Response to reviewer #1

1. Original manuscript (title): "Ambient methane monitoring at Hohenpeißenberg utilizing photoacoustic spectroscopy and cavity ring down spectroscopy"

We changed the title of the manuscript to "Comparison of photoacoustic spectroscopy and cavity ring down spectroscopy for ambient methane monitoring at Hohenpeißenberg"

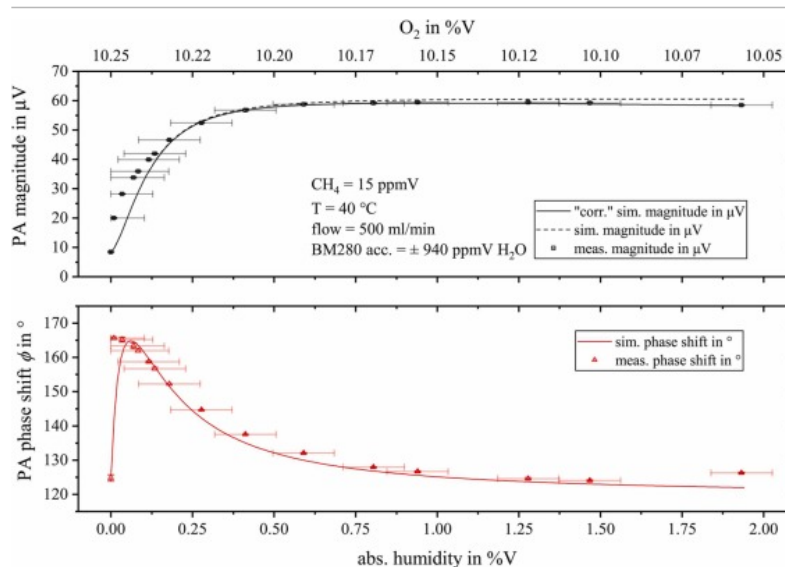
10. Original manuscript (line 105): “During the measurement campaign, the target gas was used a total of seven times for 30 minutes per interval to avoid and detect potential sensor drifts.”

-Reviewer: **seven times for 30 minutes - how long was the interval?**

Over the whole measurement period the two systems were calibrated a total of seven times, each time for 30 minutes.
